Answers to Referee 3

This article is concerned with the most recent CryoSat-2 processing and dataset version, Baseline-D, which has been operational since May 2019. The paper provides an overview of the main updates and improvements since the previous Baseline-C version, both at Level-1B and Level-2 stages. The discussed improvements at L1B stage are: Transition to the more ergonomic NetCDF file format from EEF; the eradication of anomalously negative radar freeboards at the SAR/SARIn mode boundary; the inclusion of two additional stack parameters; and inclusion of the USO correction to the window delay parameter. Improvements at the Level-2 stage are; transition to NetCDF format; the inclusion of sea ice freeboard data for SARIn mode; a new retracker for diffuse waveforms; improved surface type discrimination with the implementation of the Stack Peakiness parameter; implementation of new slope models for land ice elevation correction; and the inclusion of some additional parameters in the L2 files. The second half of the manuscript offers a series of land ice and sea ice comparisons/validations, either comparing the data with itself (e.g. during ascending and descending passes),

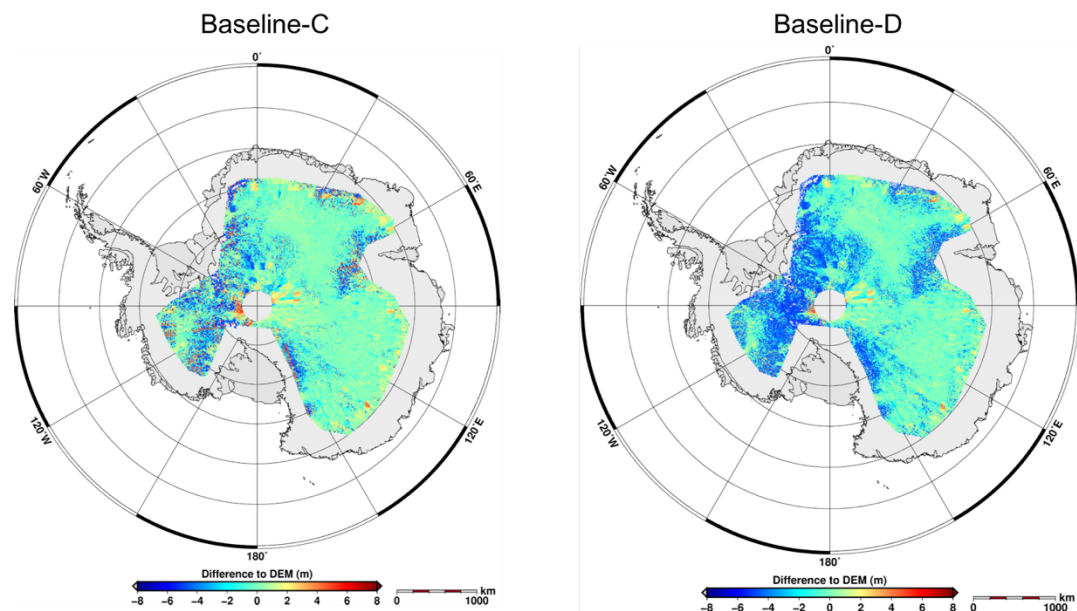
- Page 14, line 255 - “This slightly changes the LRM slope corrected elevation”. What does slightly mean? 1% ? 10% ? Please quantify the change.

- Page 14, line 256 - "... for a large area in East Antarctica...". Can you explain why you chose this area? Please also include a map of Antarctica or East Antarctica to show where this region is.

- Page 14, Figure 3. Please say in the caption what the numbers are, i.e. “Mean REMA-CS2 difference= $+0.13 \pm 1.2$ m” etc

Reply: The changes are quantified in Figure 3. We found mean differences to REMA for the slope corrected height of ICE1 retracker:

We excluded outliers which differ by more than ± 20 m.

Baseline-C:

Mean : -0.10569497
Median : 0.10062109
Std Dev : 1.7323635
Number of points: 17050710

Baseline-D:

Mean : -0.93375798
Median : -0.34570312
Std Dev : 2.0853337
Number of points: 17079280

The slope model used to estimate the slope correction in the L2 product is different between both Baselines. This means that the relocated position (lat/lon) and the slope corrected elevation differs along track. Therefore, a percentage deviation cannot be specified. Figure 3 gives an idea of the spatial differences of the changes one can expect. We changed Figure 3 and show now the full LRM zone, not only a region.

Reply: The region was chosen to cover slopes between 0 to 0.25° and to be able to distinguish differences in a figure. If needed we could add another region. We have modified Figure 3, as per previous comment.

Reply: we acknowledge the referee suggestion and we will implement it in the new version of the manuscript.
